Re: | Response to Independent Expert Report - Groundwater Modelling Review

Following the public exhibition of the *Hume Coal Project Environment Impact Statement* (EIS), the NSW Department of Planning and Environment (DPE) engaged Hugh Middlemis of Hydrogeologic Pty Ltd to conduct an Independent Expert Review of the Hume Coal Project EIS Groundwater Model and related modelling elements (Coffey 2016a,b). A draft copy of Hydrogeologic's *Hume Coal Project EIS Independent Expert Review Groundwater Modelling* was issued to Hume Coal in December 2017 (Attachment A).

In response to the Hydrogeologic report and submissions received during the exhibition period, Hume Coal engaged HydroSimulations to review the Hume Coal EIS Groundwater Model and update where required to address issues raised. The results of the HydroSimulations modelling work are presented in *Hume Coal Project Revised Groundwater Modelling for Response to Submissions* (HydroSimulations 2018) (Attachment B).

Figure 3 Groundwater model 'interburden' thickness

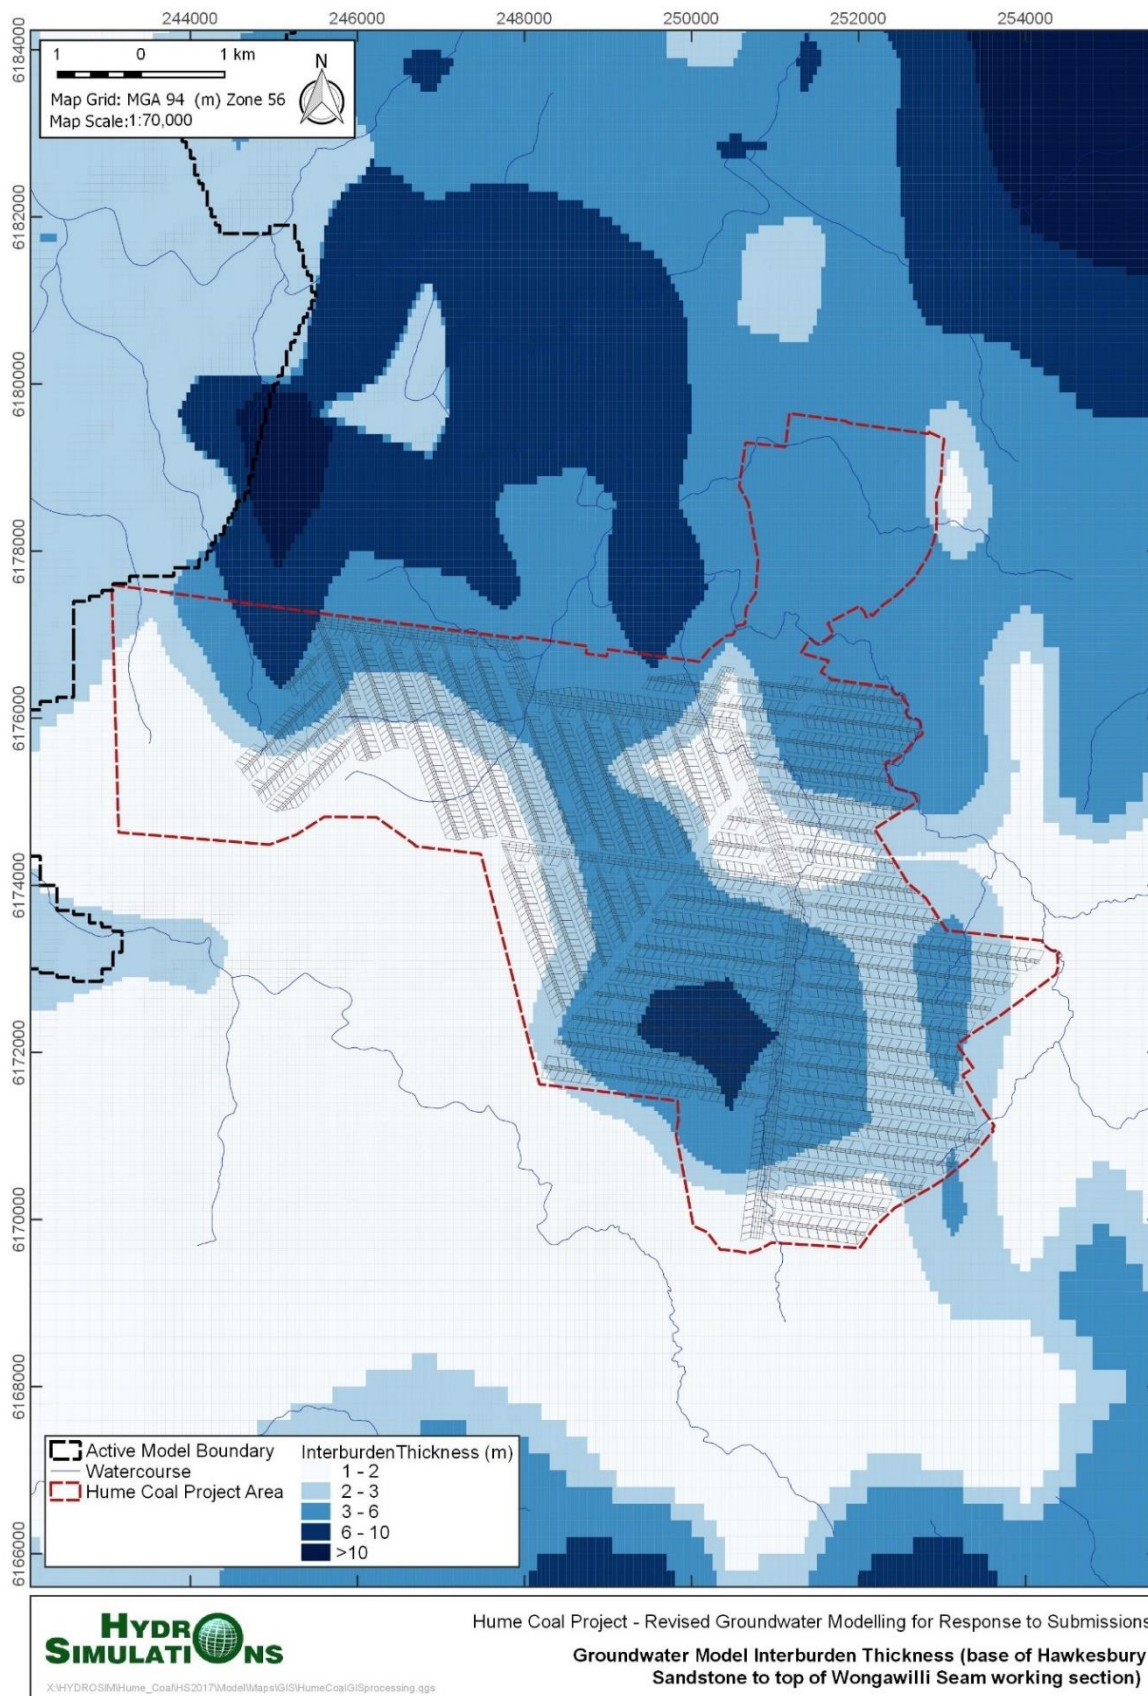
HydroSimulations conducted an examination of the model geometry which showed that the interburden between the bottom of the Hawkesbury Sandstone and the top of the working section of the Wongawilli Seam is spatially variable, and closely matches the interpolated interburden thickness figure shown in the EIS groundwater report (Coffey 2016a, Figure 4.3).

Figure 3 shows the modelled thickness in metres of the interburden surrounding the proposed Hume Coal Project area; it is comprised of the cell-by-cell sum of the thickness from the top of model layer 8 to the base of model layer 10. It should be noted that a model layer built using the software available when building the EIS model (MODFLOW SURFACT V3) required fully extensive layers of non-zero thickness. In the model, the area outside the Hume Coal Project Area has an interburden thickness of approximately 1m which is comprised of:

Figure 63 Cross section showing the behaviour of a groundwater model without pseudo soil function enabled (EIS Model)

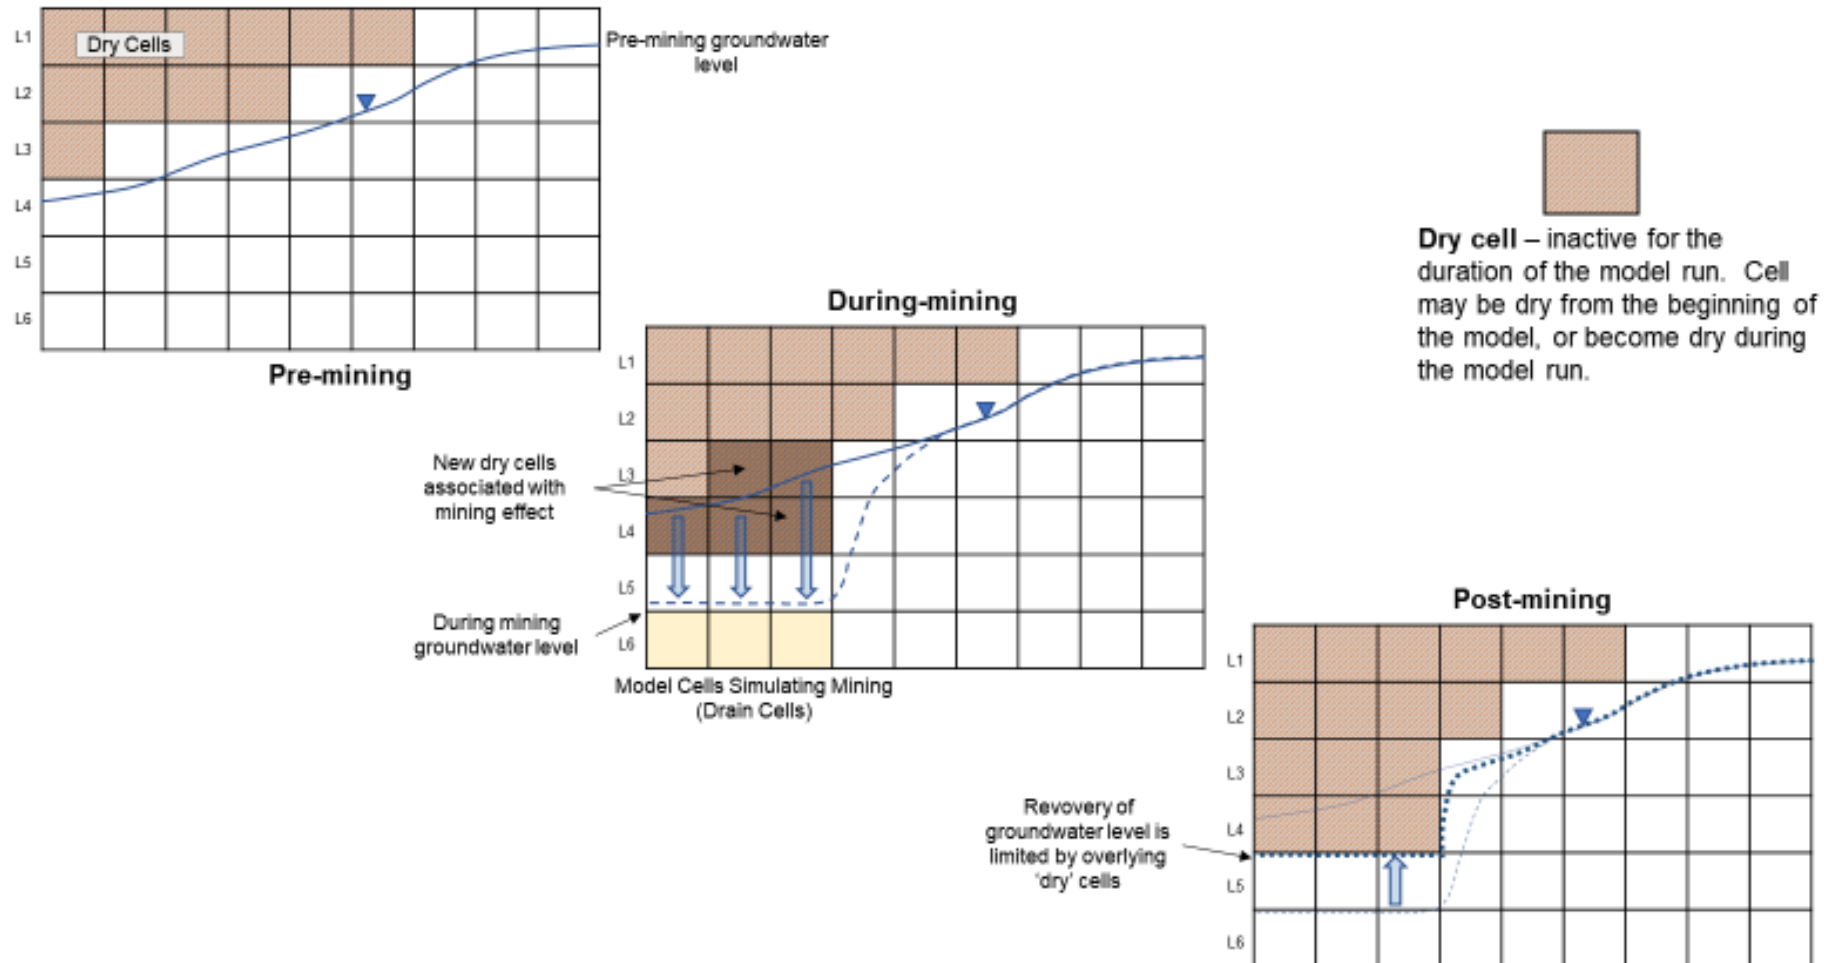
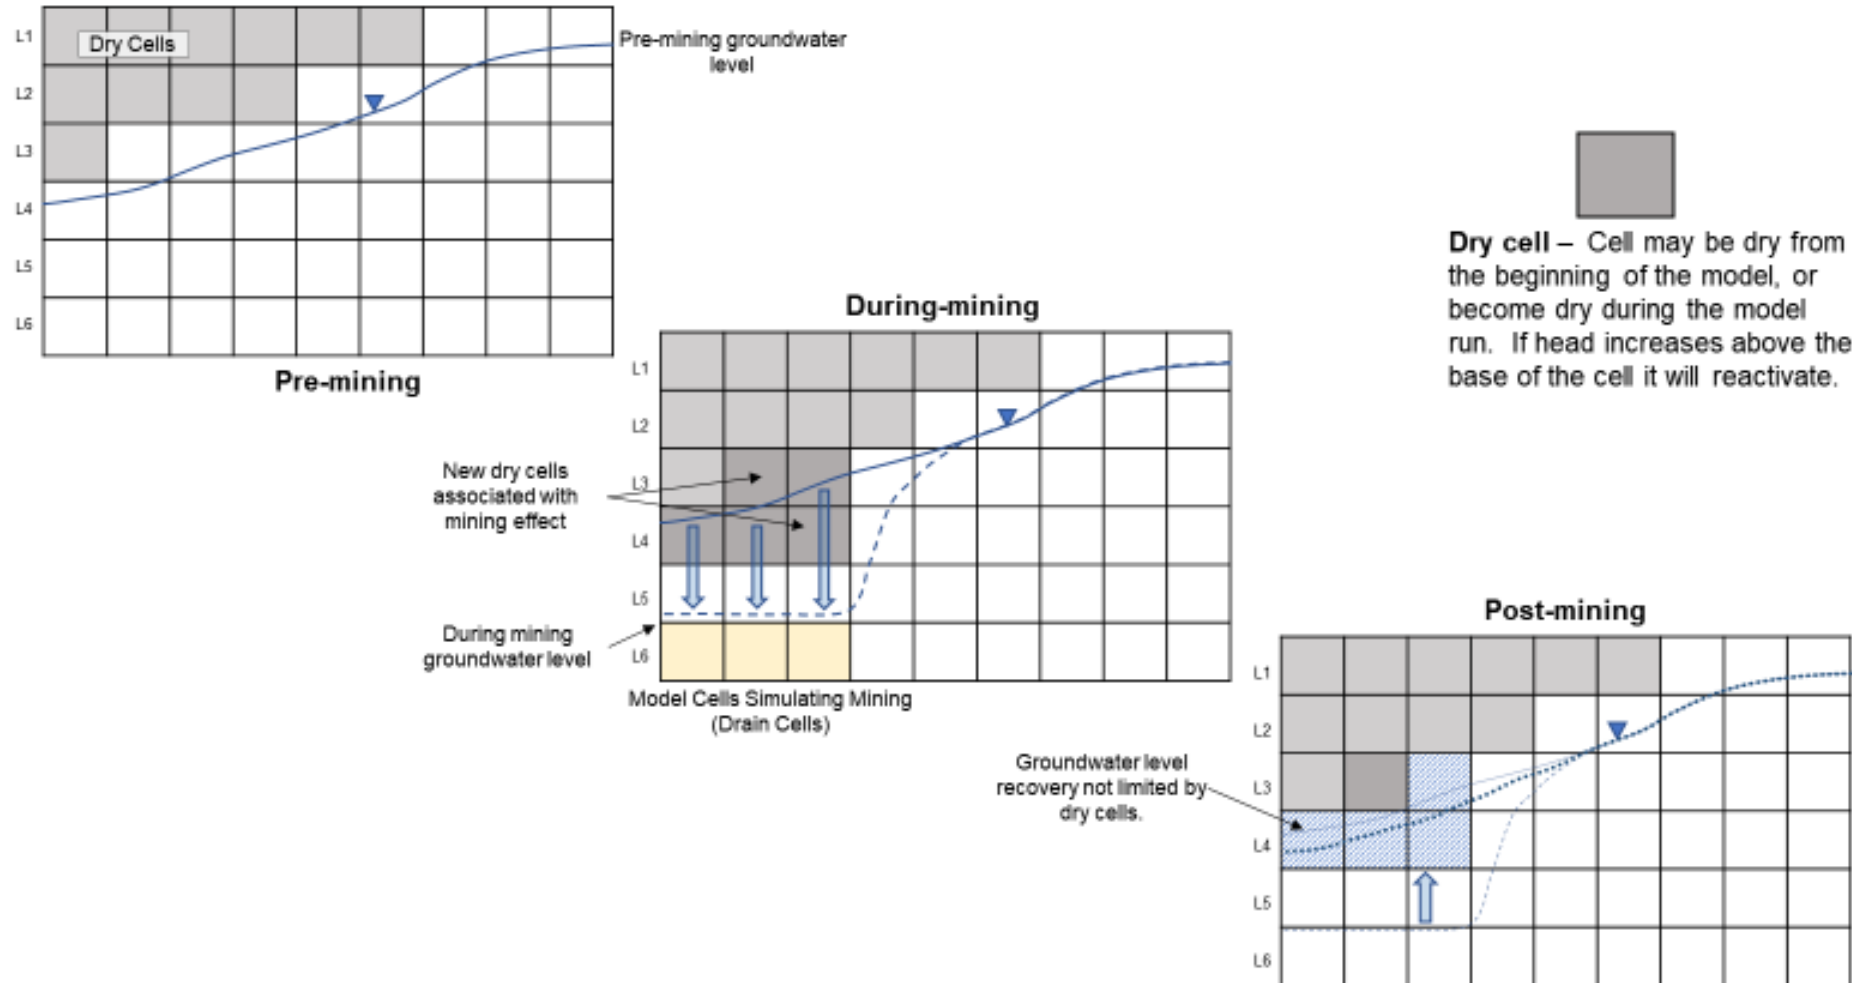
Figure 63 shows a cross section view of the behaviour of a groundwater model without the pseudo soil function enabled. By way of contrast, **Figure 64** shows a cross section view of the behaviour of a groundwater model segment with the pseudo soil function enabled.

Figure 5.4. Methodology used in the numerical model to simulate mine drainage and post-mining recovery.

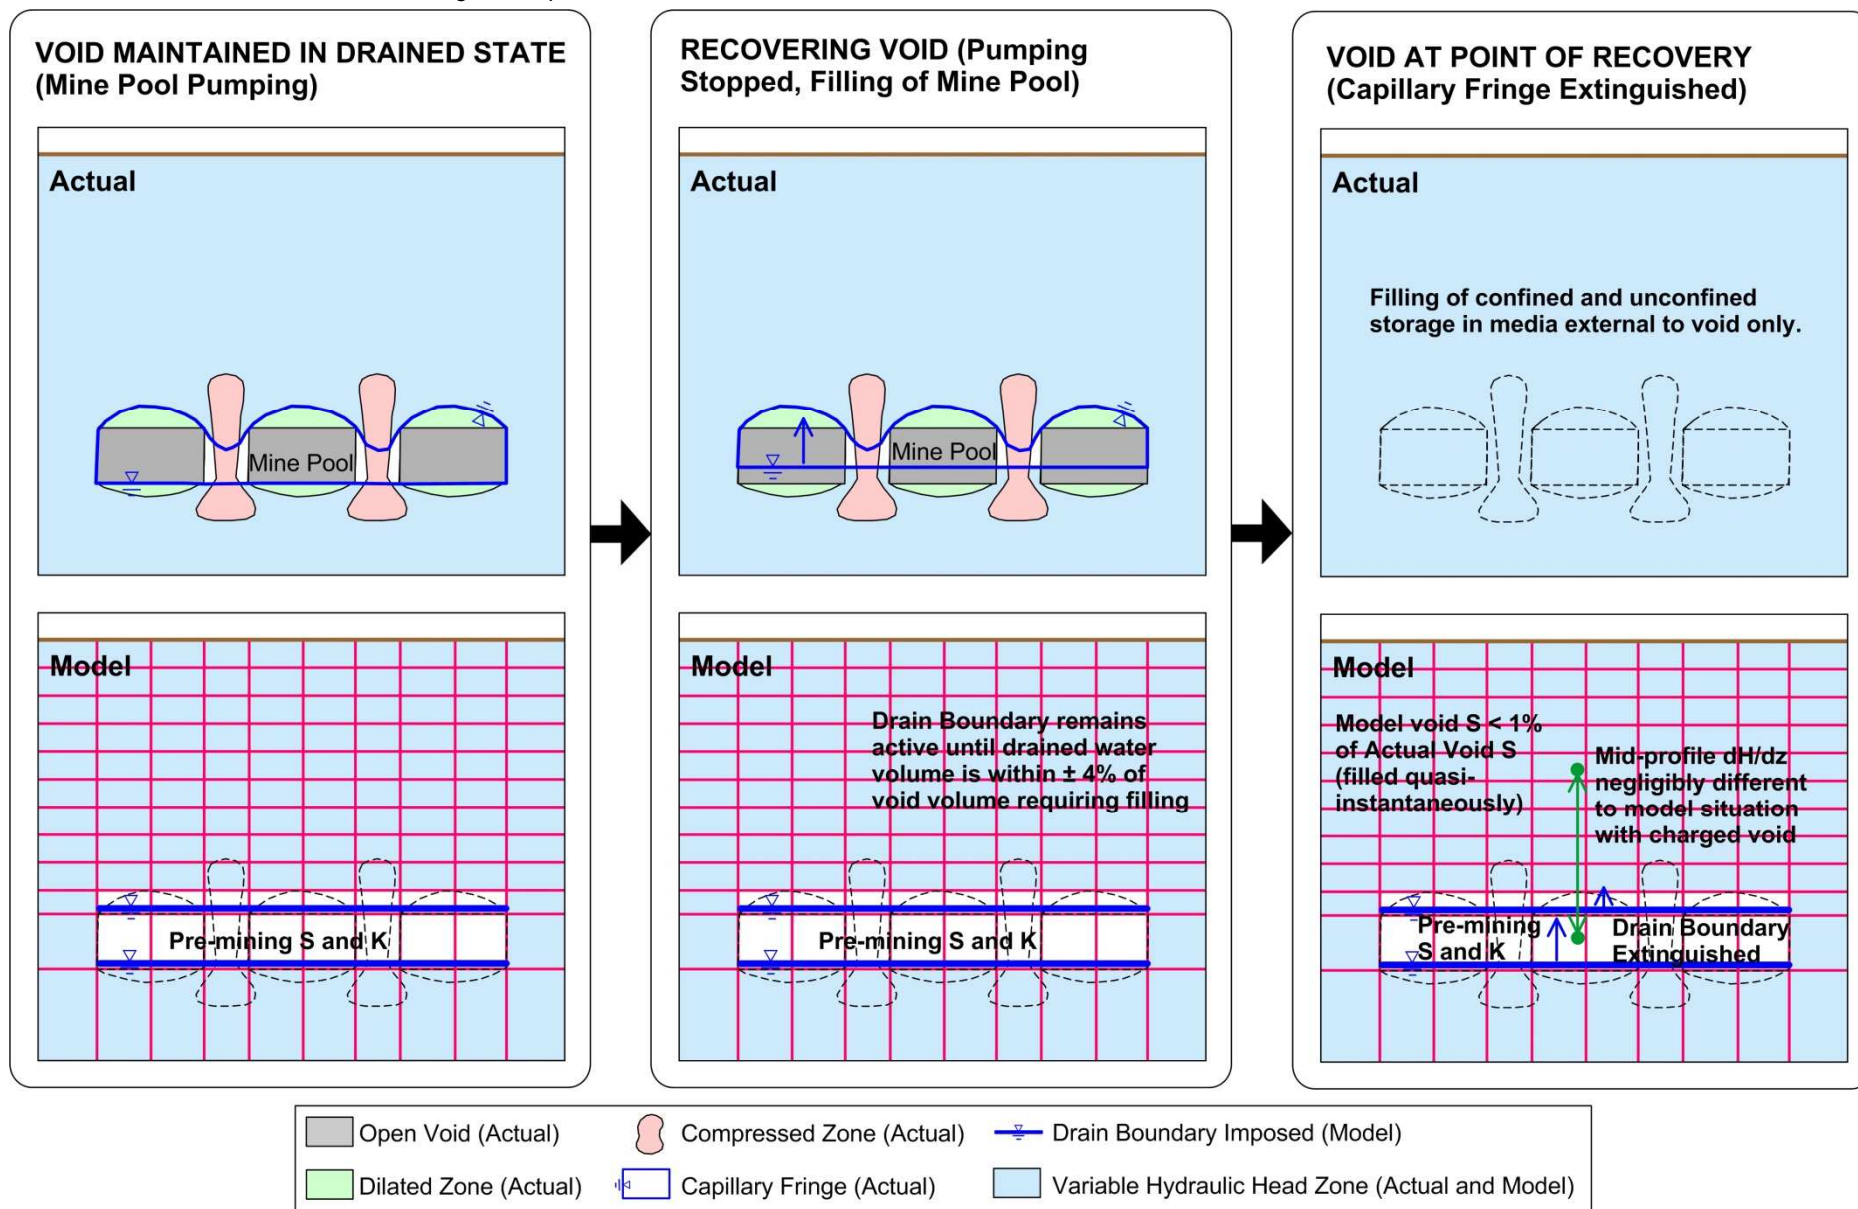
The Hume Coal model applies the “Drain” feature of Modflow to simulate groundwater inflows to the mine workings (a standard methodology); see also Figure 3 (later). The drain feature involves a conductance parameter that acts as a resistance to flow (i.e. lower values of conductance require higher groundwater levels to result in the same amount of inflow).

The groundwater-related effects of potential bulkhead failure were not specifically considered in the EIS, but the results that have been provided can be interpreted to provide some useful information on the issue. The groundwater assessment modelling method included leaving drain cells active after mining until the residual void behind the bulkhead is filled, and then deactivating the drain cells (Figure 3).
